1 46. Time-Sensitive Networking (TSN) configuration

2 *Change the introductory text of Clause 46 as follows:*

13 *Change 46.1 as follows:*

Figure 46-1—Fully distributed model

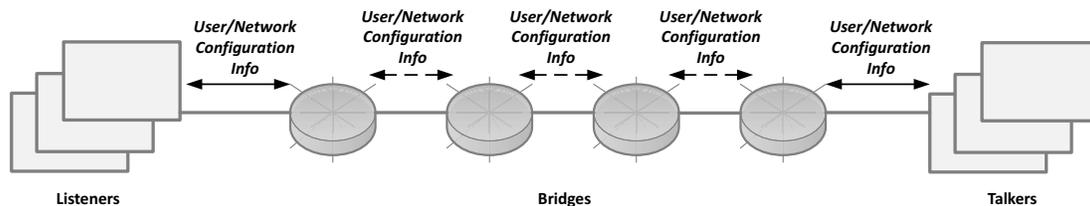
12 In the figure, the solid arrows represent the protocol that is used ~~as the UNI for~~ to exchange of ~~configuration~~
13 information between Talkers/Listeners (users) and Bridges (network). This ~~configuration~~
14 information is specified in 46.2.

15 In the figure, the dashed arrows represent the protocol that propagates ~~configuration~~
16 information within the network. This protocol carries ~~the TSN user/network~~ Stream
17 configuration information (46.2) as well as additional information ~~that is~~ specific to network configuration.

Figure 46-2—Centralized network/distributed user model

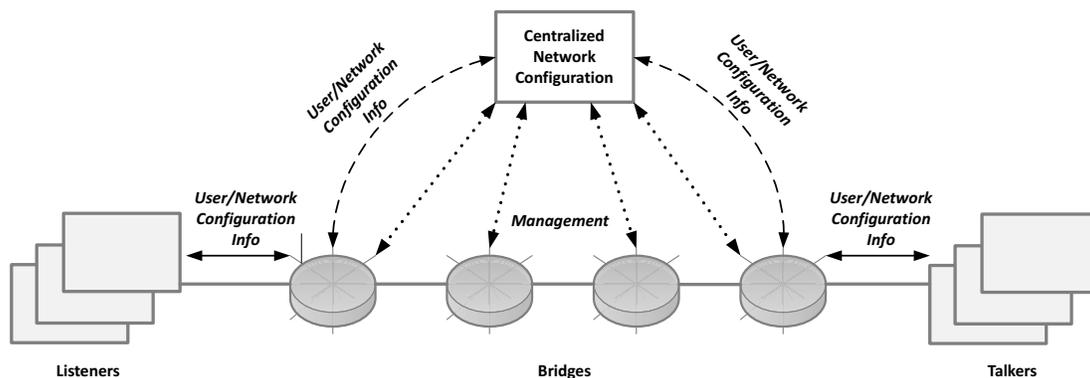
21 In the figure, the solid arrows represent the protocol that is used ~~as the UNI for to~~ exchange ~~of configuration~~
22 Stream information between Talkers/Listeners (users) and Bridges (network). This ~~configuration~~
23 information is specified in 46.2.

24 In the figure, the dashed arrows represent the protocol that transfers Stream configuration information
25 between ~~edge~~ Bridges and the CNC. This ~~configuration~~ information is specified in 46.2.

16 SRP (Clause 35) can be used as the ~~UNI~~ [Talker/Listener protocol](#) (solid arrows of Figure 46-2). SRP's MRP
17 External Control (12.32.4) feature can be used to exchange configuration information with the CNC
18 component (dashed arrows of Figure 46-2). SRP exchanges configuration information using the TLV
19 technique to reference elements in 46.2 (see 46.1.3.1). Examples of a remote network management protocol
20 (dotted arrows of Figure 46-2) include Simple Network Management Protocol (SNMP), NETCONF (IETF
21 RFC 6241 [B39]), and RESTCONF (IETF RFC 8040 [B47]).

Figure 46-3—Fully centralized model

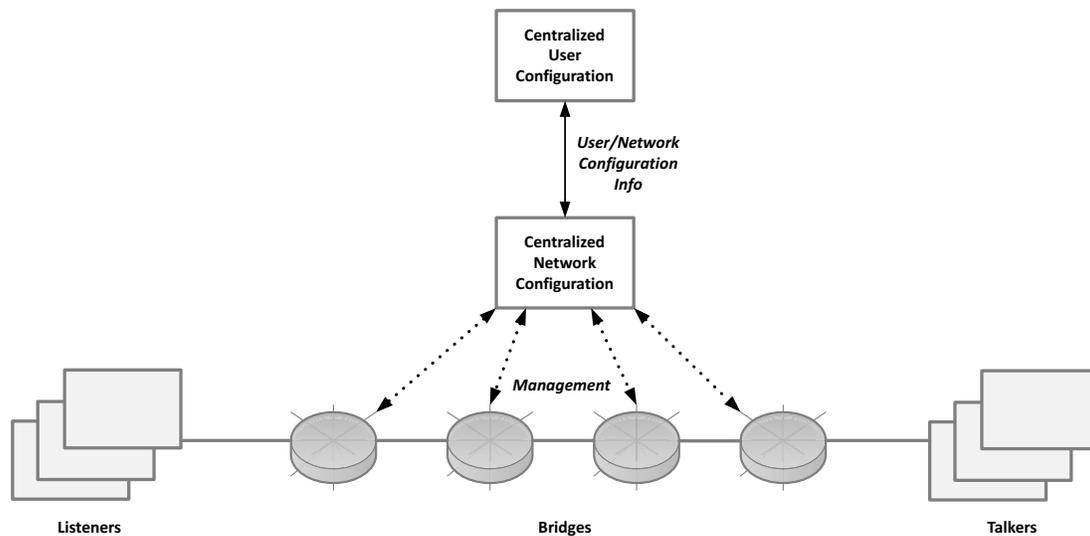
42 In the figure, the solid arrows represent the ~~protocol that is used as the UNI for~~ exchange of configuration
43 information between the CUC and the CNC. This configuration information is specified in 46.2.

6 In this fully centralized model, a protocol is used between the CUC and end stations (Talkers and Listeners)
7 to retrieve end station capabilities and requirements and to configure the end stations. ~~Since that protocol is
8 user-to-user, its configuration information is considered to be outside the scope of this standard, and it is not
9 shown in Figure 46-3.~~
